F/22/93194 Ageas development

Ecology Comments 16.11.23

Northern area of residential parcel (drainage strategy sheets 2, 1)

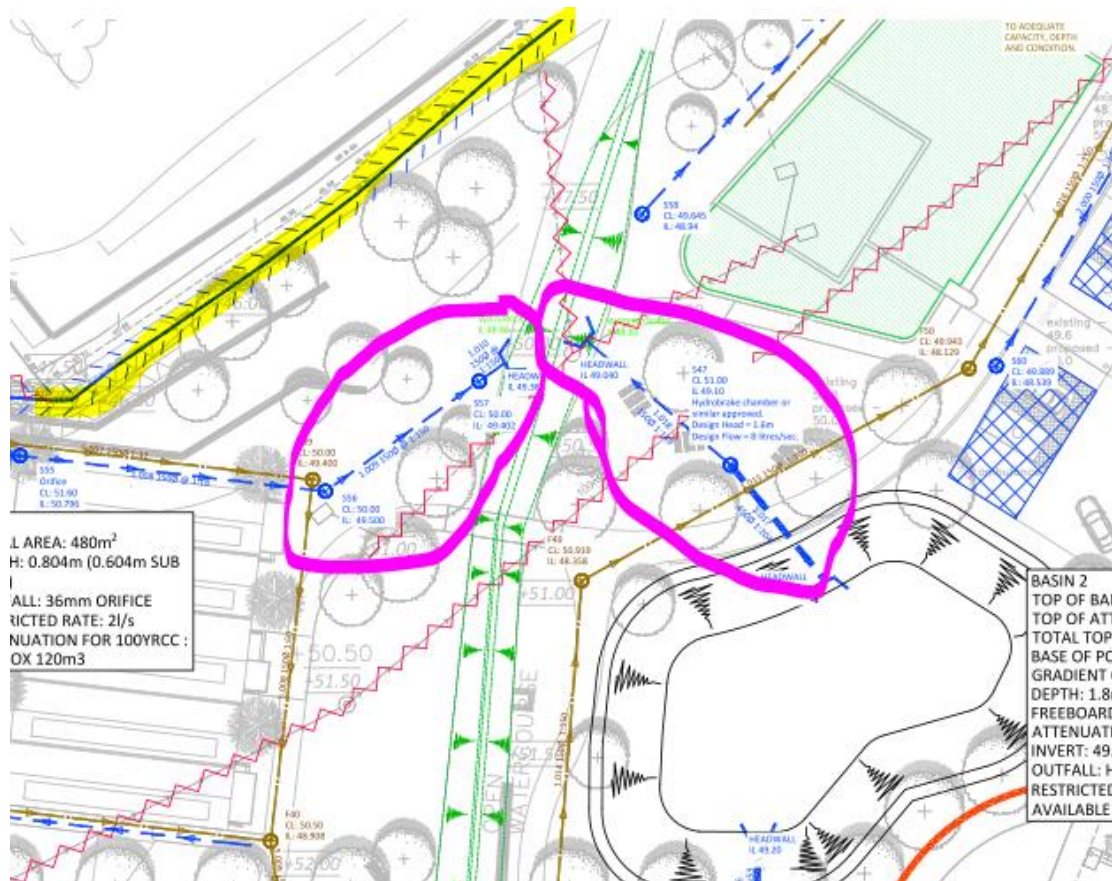
The underground pipe network should be minimised as much as possible. Could these two pipes circled pink below become open surface channels?

As the upstream culvert of the Telegraph Brook will be realigned, the highlighted stretch of watercourse above will no longer take upstream flows and will only take very localised runoff. It may also act as a backwater dependent on its bed levels and the water levels in the realigned and retained connected stretches of the Telegraph Brook.

Wellbeing centre (drainage strategy sheet 5)

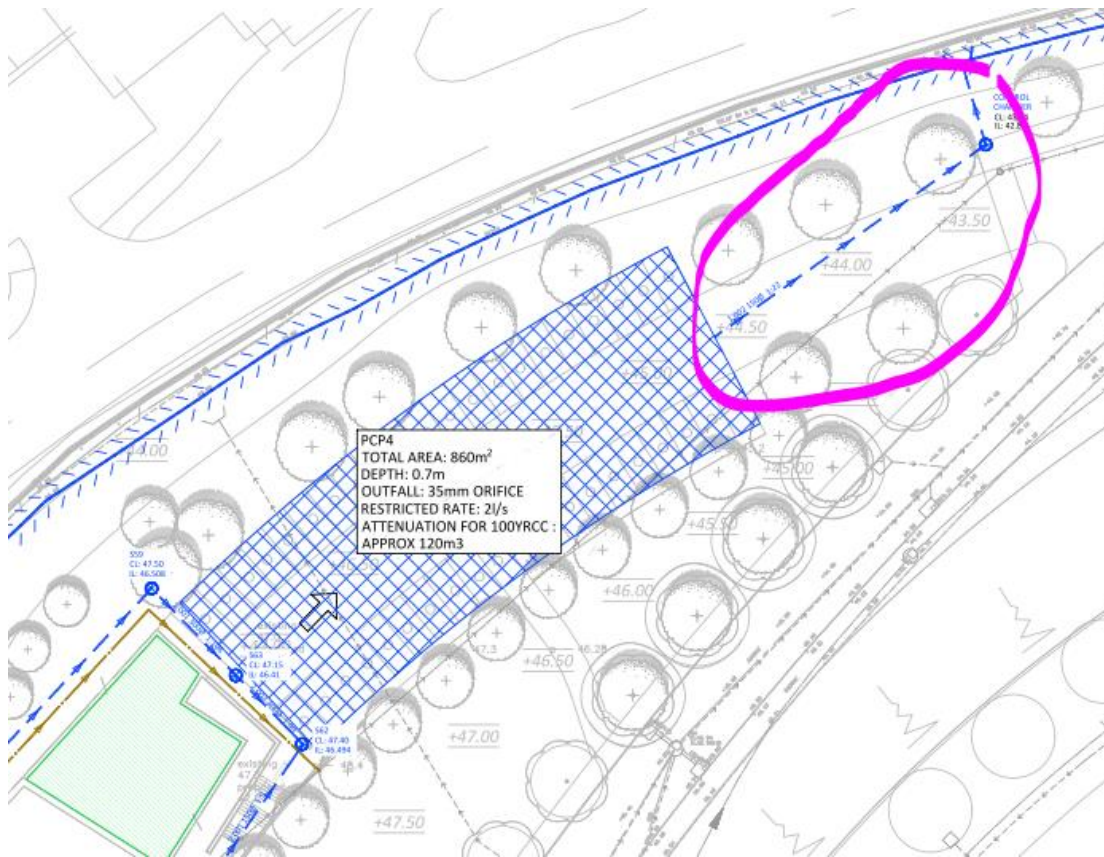
The underground pipe network should be minimised as much as possible. Is there scope to change the pipe circled pink below to an open surface channel?

Residential home (drainage strategy sheet 9)

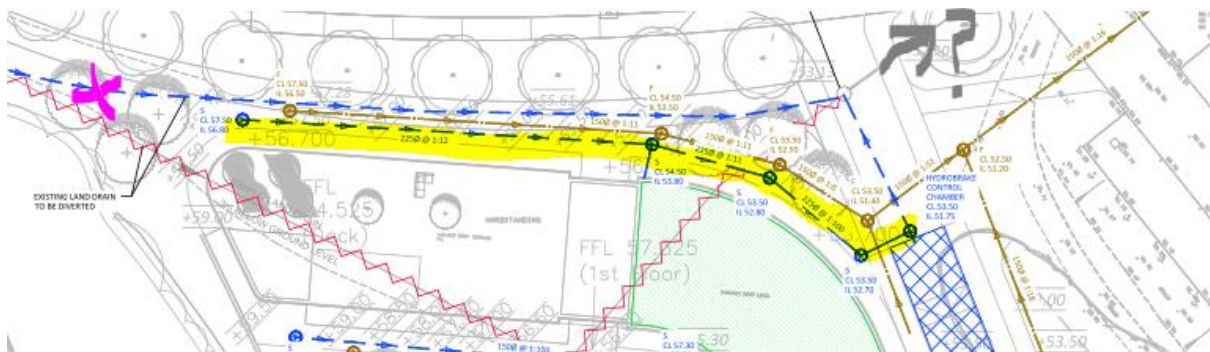
The surface water pipe highlighted below appears to be a new surface water drain but does not pass through any form of filtration prior to discharge. This needs to be corrected with sufficient filtration provided.

It is unclear where the surface water pipe marked with a pink x below is from. Is this taking runoff from the new development and what treatment has this runoff undergone prior to discharge?
